Doering Valve

DRAFT Russ 2/7/13 5:05pm (1705) (2/2/13)

Doering Valve & Cavity +045

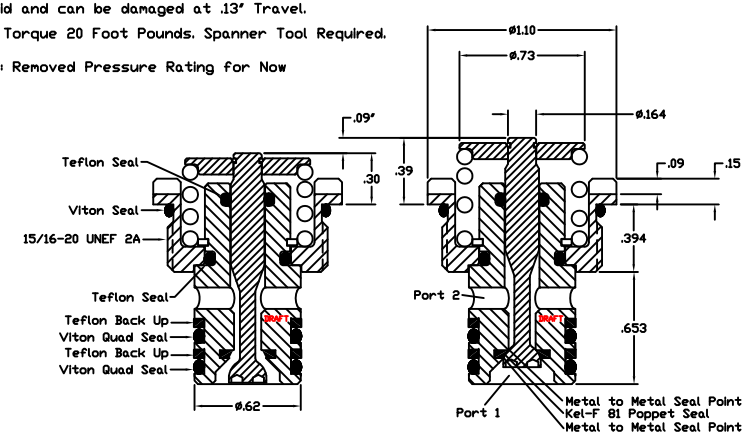
2/7/13 5:05 pm (1705), Russ: Change Second O-Ring Configuration and add .045 to accommodate.

Orifice ø.158 with ø.095 Restriction
Throttle of Flow area = .0125 Inch^2
Full Flow Achieved at .08" Travel.
Recommended Stroke .09"
Valve is Solid and can be damaged at .13" Travel.
Installation Torque 20 Foot Pounds. Spanner Tool Required.

2/7/13 Russ: Removed Pressure Rating for Now

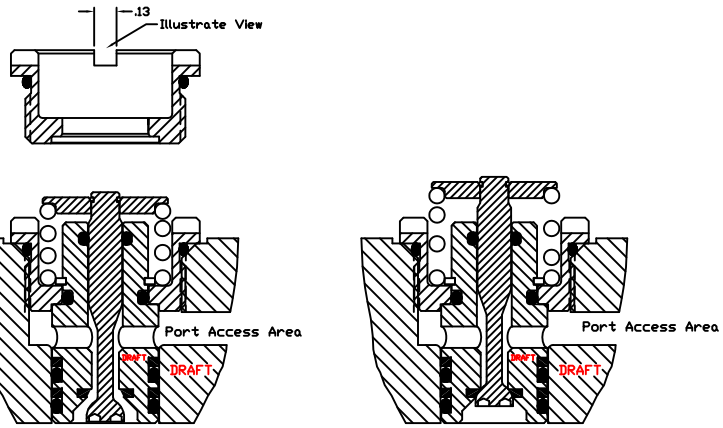
Slot Width .13". Not previously illustrated.
